8 cyl. 12" - 15"
M/V "HADA"

3 plans of Oil Gland are enclosed herewith.

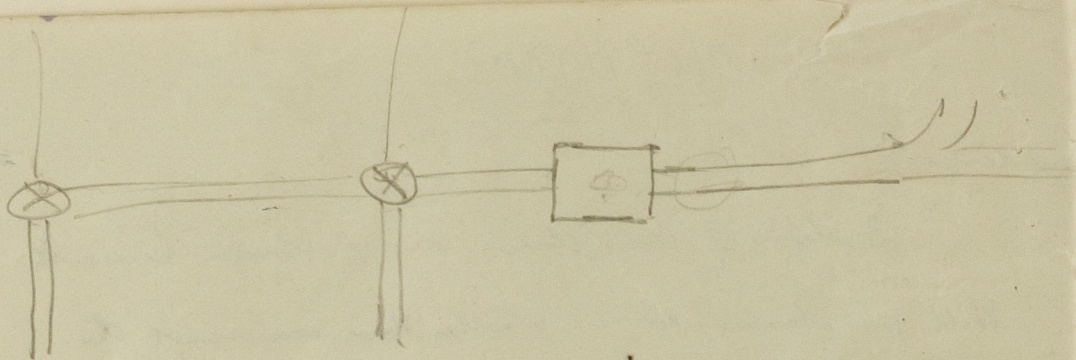
Will you please advise whether these warrant the
"O.G." notation?

The plan of the oil gland has been
examined & the design as shown therein
so much as could be accepted, in this instance,
for notation of "O.G."
